Cumberland County
Subdivision and Land Development
Review Report

Municipality:	Date Received:	Date Reviewed:	Reviewed By:	Plan Number:
North Middleton Township	1/9/2026	1/26/2026	NB, SH	P26-24
<i>Plan Title:</i>				
<i>Mountain View Estates Phase 6</i>				
<i>Plan Status:</i>		<i>Plan Type:</i>		
<i>Final</i>		<i>Subdivision Plan</i>		
<i>Comments and Recommendations:</i>

FINAL SUBDIVISION PLAN FOR MOUNTAIN VIEW ESTATES - PHASE 6

OVERALL PHASING PLAN
FINAL SUBDIVISION PLAN
FOR PHASE 6
MOUNTAIN VIEW ESTATES
NORTH MIDDLETON TOWNSHIP, CUMBERLAND COUNTY, PENNSYLVANIA

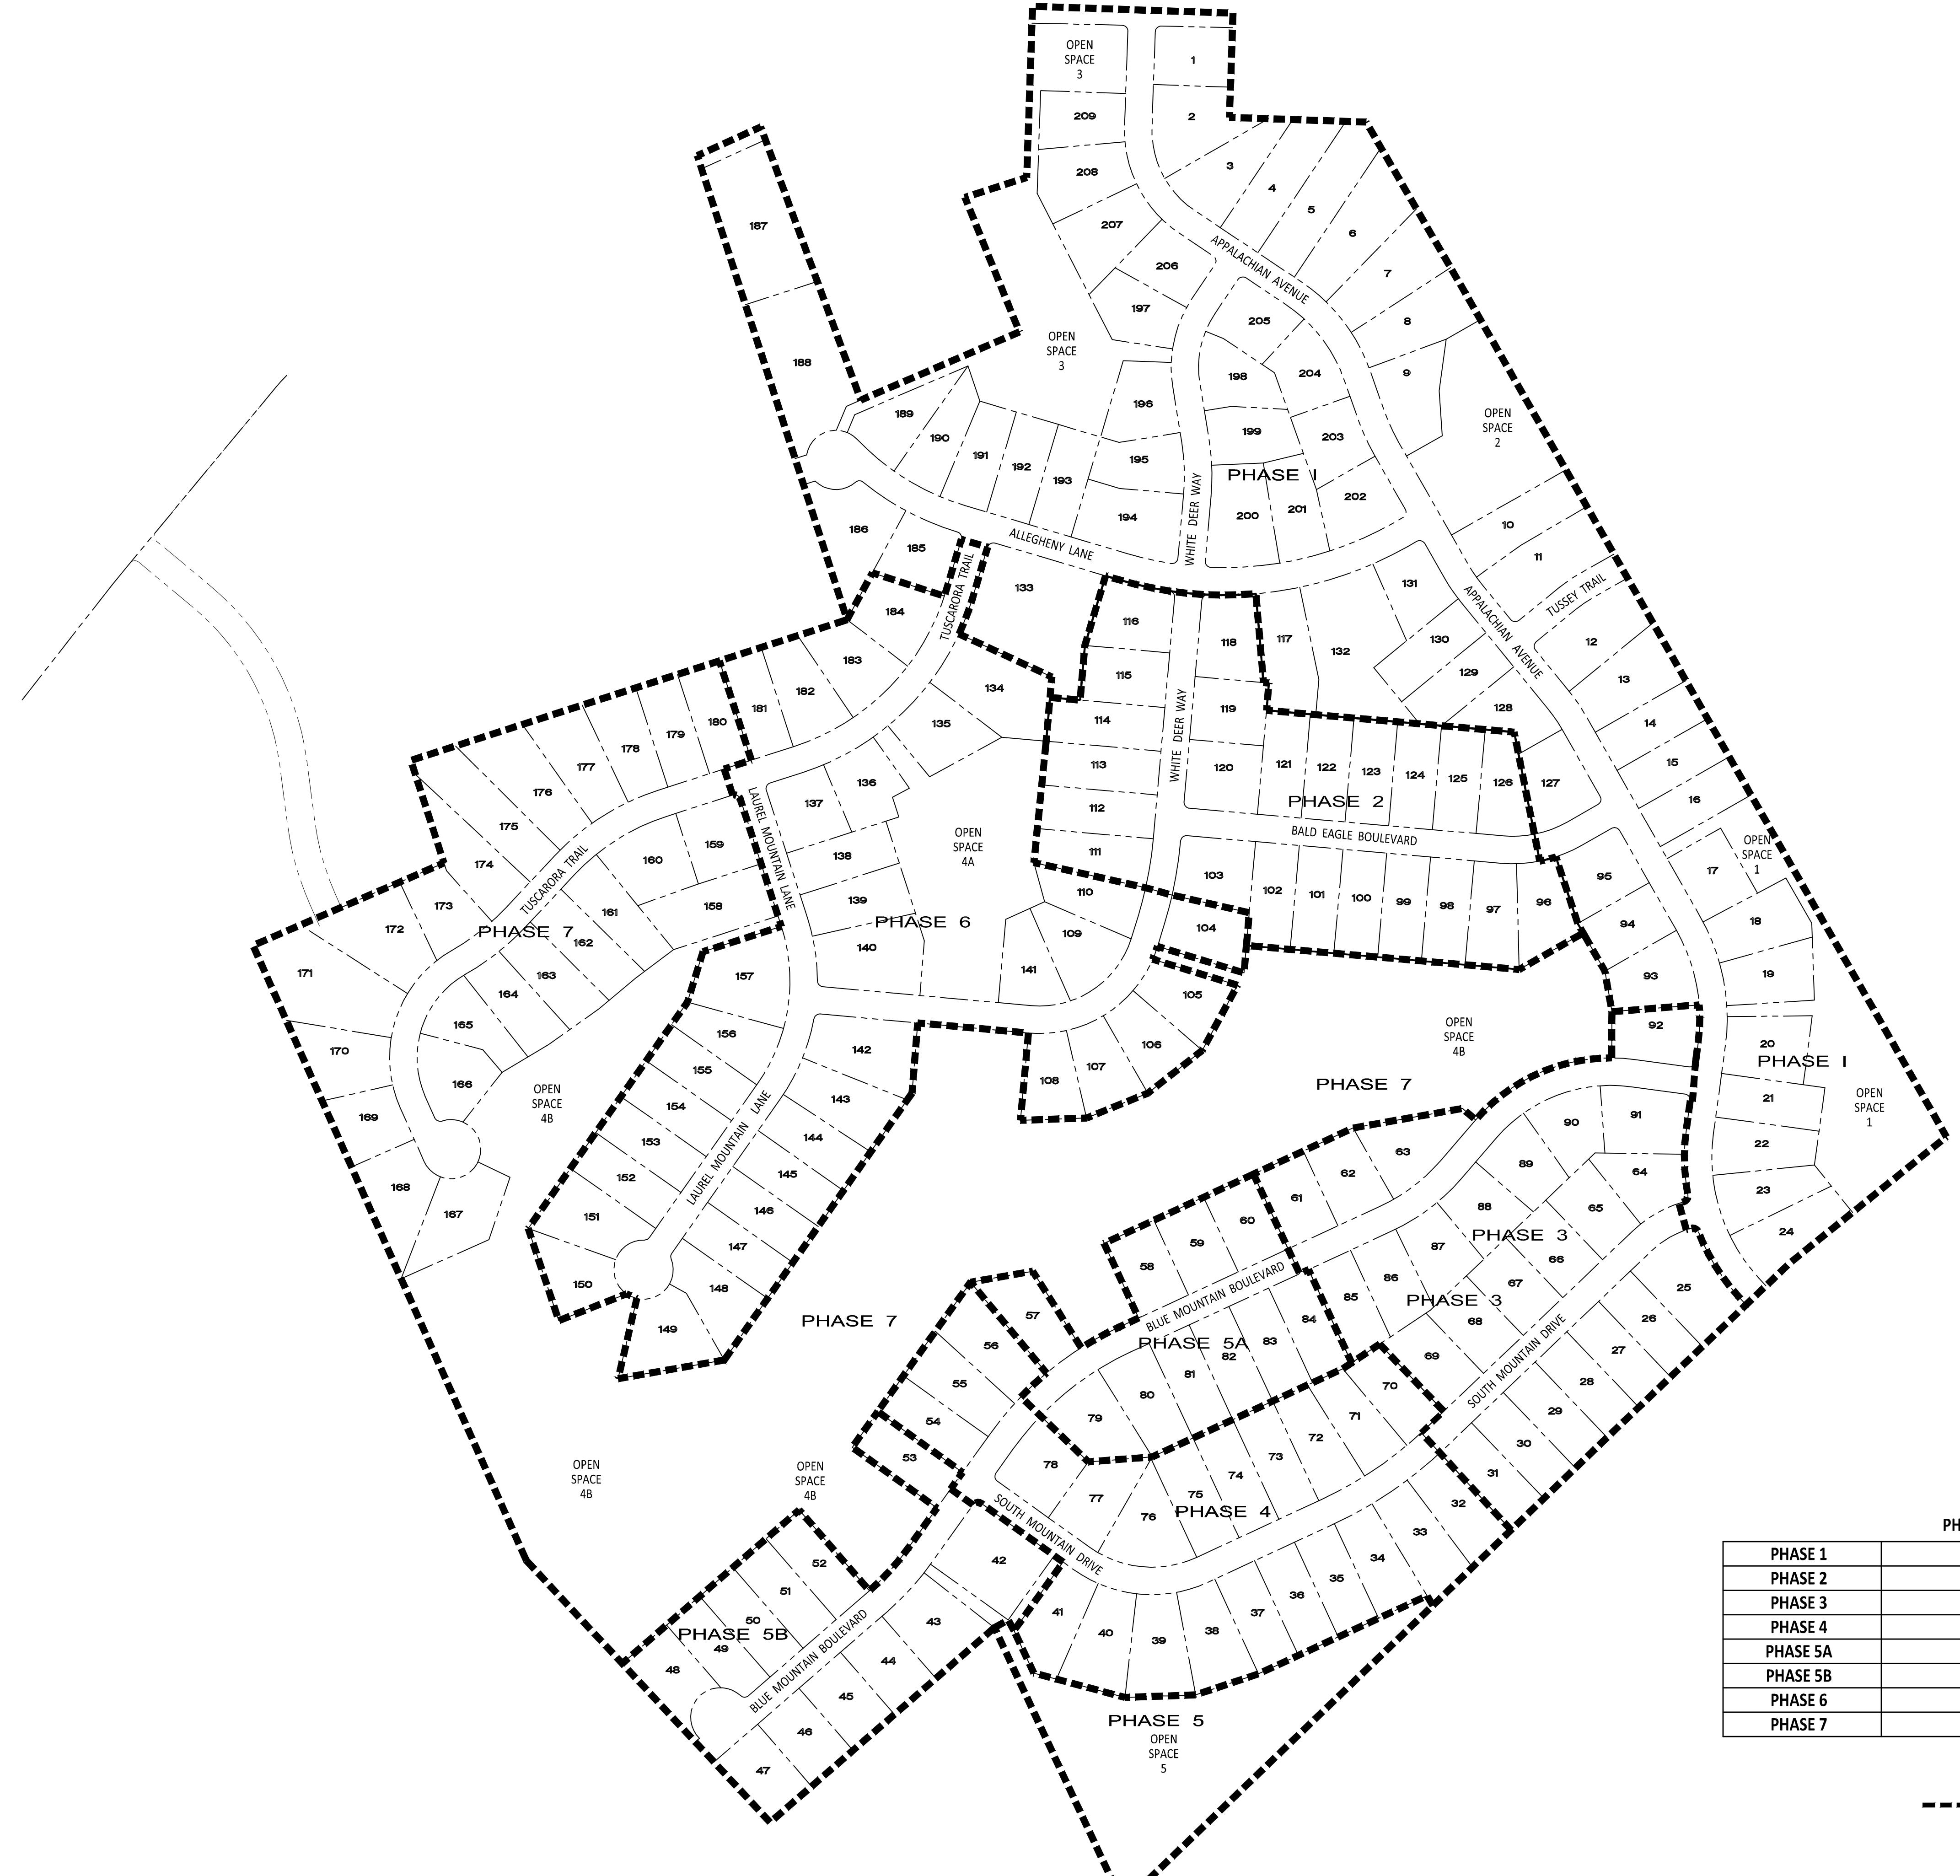
1. The cul-de-sac at Blue Mountain Boulevard should include a snow dump easement (SLDO 180-34.F.6).
2. The applicant should include an explanation of the lots 48-63 adjacent to Blue Mountain Boulevard. Some of these lots appear to be previously approved in the final subdivision plan for phases 4, 5A and 5B and others appear to be in phase 7 as shown on sheet 2.
